FOUR OAKS ADDITION

RE: S/D 98-123 -- One-Step Final Plat of FOUR OAKS ADDITION

At the regular meeting of the Subdivision Committee of the Metropolitan Area Planning Commission on Thursday, December 31, 1998, the above captioned plat was considered. The action of the Committee was to approve the plat, subject to:

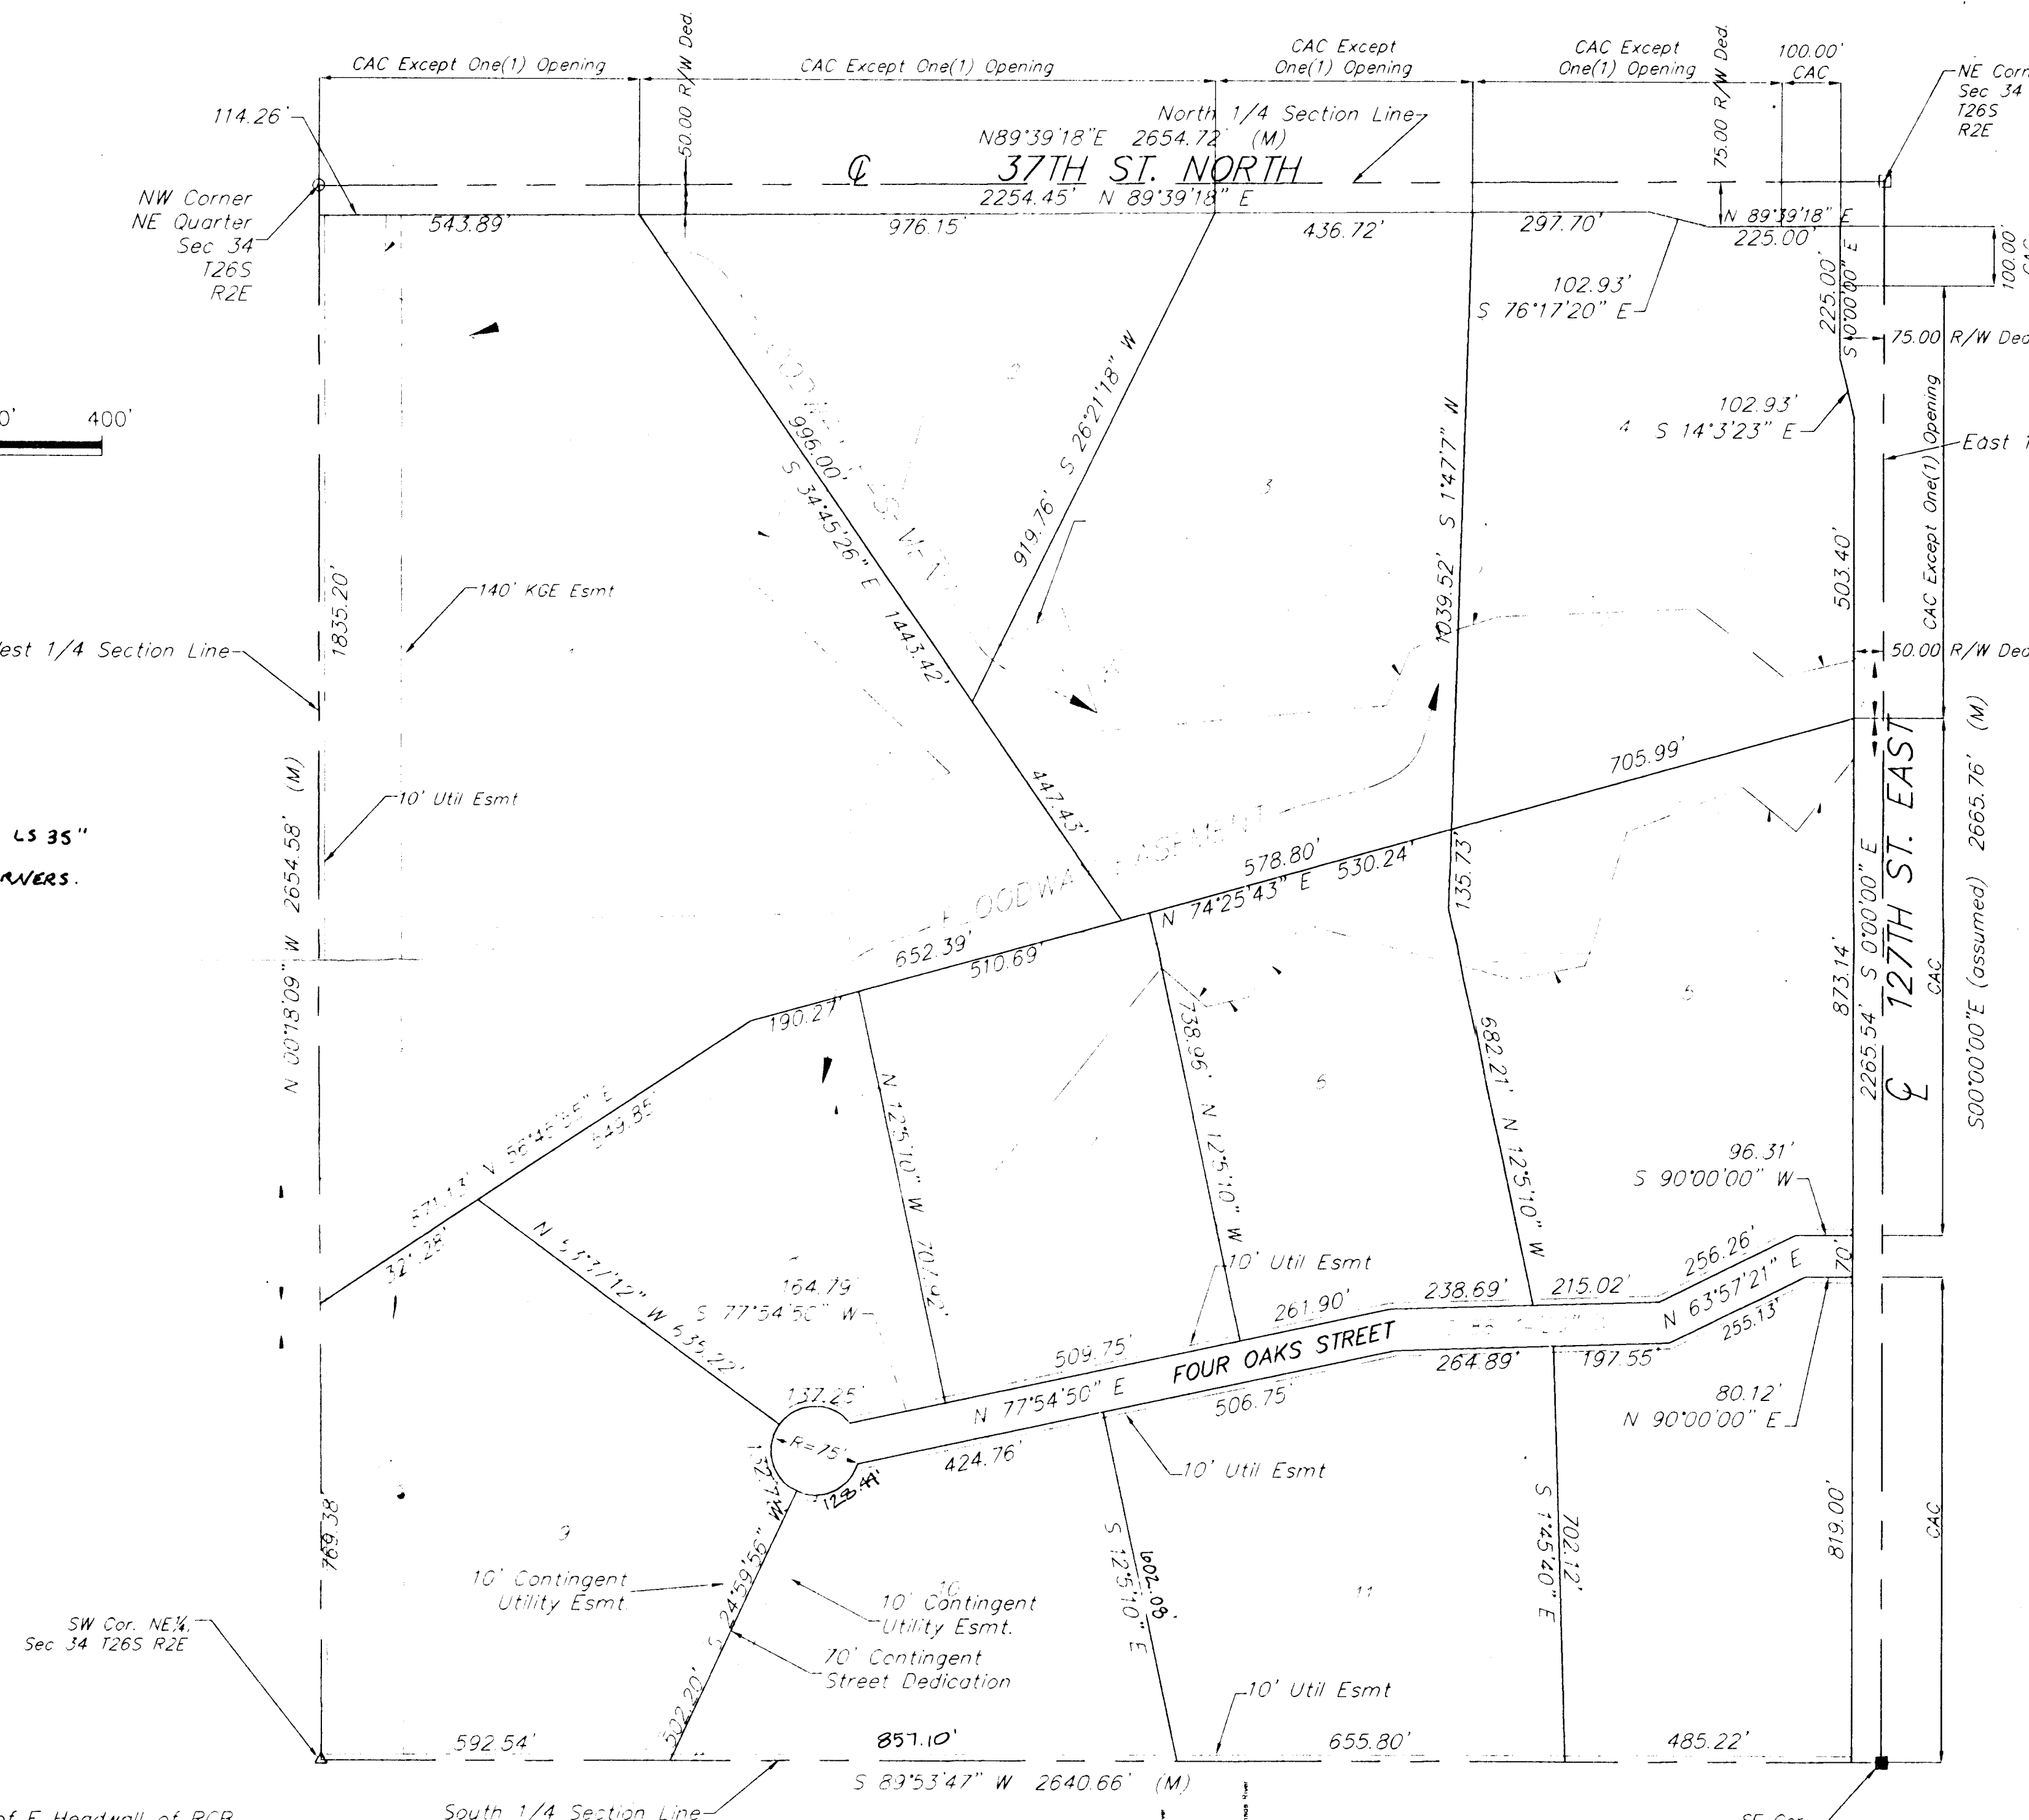
- D. County Engineering needs to comment on the status of the applicant's drainage plan. The floodway reserves need to be denoted.
- E. The final plat tracing shall denote complete access control along 127th St. East for Lots 5 and 12. Access controls denoting one access opening per lot is requested for the lots abutting 37th St. North. County Engineering needs to comment on any additional access controls at the intersections. The final plat tracing shall reference the access controls in the plat's text. County Engineering requires 100 feet of complete access control from each intersection.

- F. County Engineering needs to comment on the need for right-of-way for perimeter streets, in addition to the need for a major intersection right-of-way. The plat currently denotes a 25-ft half street right-of-way. The Subdivision regulations require at least a 50-ft half street right-

of-way for section line roads. County Engineering requires 50-ft rights-of-ways for perimeter roads, in addition to a 75-ft major intersection right-of-way.

- ✓ I. The applicant's agent shall determine any setback requirements for the pipelines by researching the text of the pipeline agreements. If a setback from the pipeline easements is provided for in the pipeline easement agreements, it shall be indicated on the face of the plat and further noted that the setback is a building setback line for the Williams Natural Gas Company pipeline.

- ✓ C K. The plat shall reference a tie point to a section corner.
- L. The owner's certifications shall reference "lots and a street".
- ✓ C M. Since the site is located within three miles of Wichita's City limits, the City Council signature block needs to be added.

- ✓ P. The turnaround of the interior street should be increased to a 150-ft diameter.
- ✓ Q. A contingent right-of-way should be dedicated between lots 9 and 10 for future access to adjoining properties at the south line of the plat. The platlor's text shall reference the dedication.

- ✓ T. The final plat tracing shall indicate bearings for all side lot lines which are not at right angles with or radial to adjacent street lines.
- ✓ U. The applicant shall install or guarantee the installation of all utilities and facilities which are applicable and described in Article 8 of the MAPC Subdivision Regulations. (Water service and fire hydrants required by Article 8 for fire protection shall be as per the direction and approval of the Chief of the Fire Department.)
